PRODUCT UPDATE BULLETIN

Product Effected – 3.0L GMPT RH & RL Engines
Date of Bulletin – 04.16.2008
Category – Ignition
Bulletin No. – 042008B

New RL & RH plug wire configuration

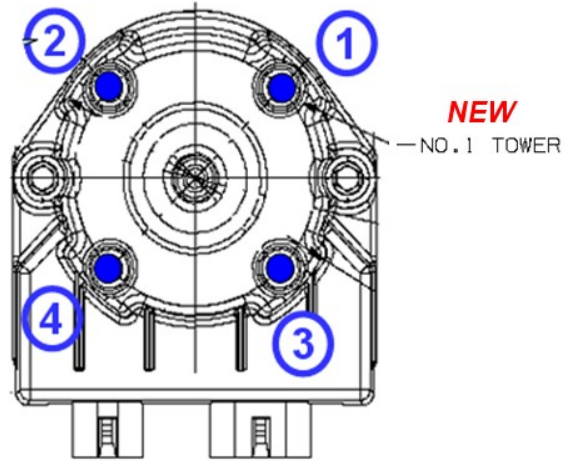
Effective on the above build date, the EST distributor tower numbering and spark plug wiring on the RH and RL 3.0L engines will be revised.

There are no new part numbers required to make this change, only a change in the EST distributor installation procedure and spark plug wire routing from the GMPT factory. It is noted that the firing order for all 3.0L engines will remain 1-3-4-2. And this change has no impact on engine performance or emissions.

**New "Common" EST
Distributor Orientation**

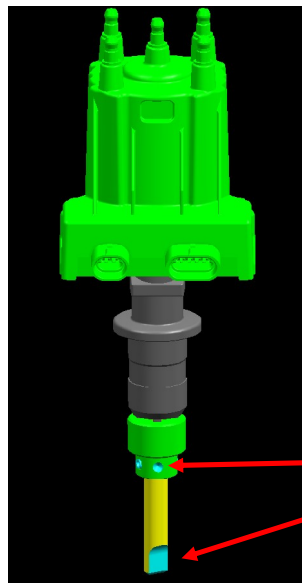
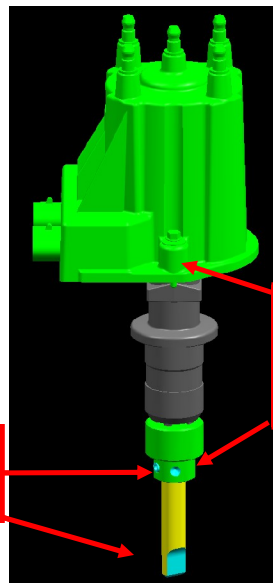
To utilize the EST distributor with new tower locations as shown above, the rotor cap is rotated 1 quadrant clockwise (as viewed from above) prior to installation in the engine, and the plugs wires are also installed on the towers one quadrant counterclockwise. The figure below shows the distributor cap and shaft alignment as described above.

The technician in the field should be aware of the differences between the old and new plug wire configuration. If they are replacing a distributor on an engine built after the date break supplied they should install the distributor and plug wires as shown in this bulletin as the "NEW" wire configuration.

They will need to align the driven gear mark with the mark on the distributor cap (as shown in the picture below on the right).
